Audi A3 (8P)

Lack of cooling performance and noises from the engine compartment

Bulletin

Fig. 1

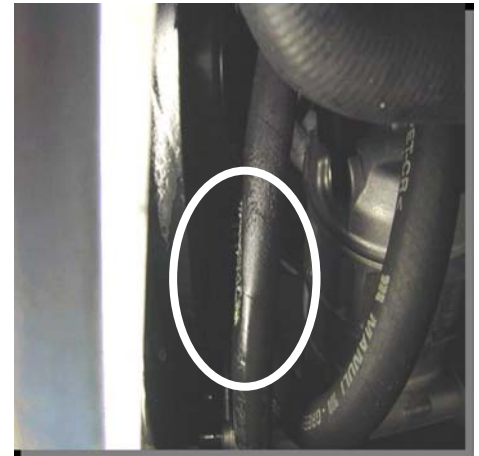
If there are complaints about the above-mentioned faults, the cause could be a worn refrigerant hose (Fig. 1). Due to an incorrect angle of the refrigerant hose from the compressor to the condenser (high pressure line), the hose can come into contact with the radiator fan.

In this case the hose and fittings have to be replaced. The new hose must then be fixed in place using a closed clip (Fig. 2) or a cable tie, in such a way that contact with the radiator fan is no longer possible. From chassis number 8P4A017591 onwards improved refrigerant hoses with modified angles have been used.
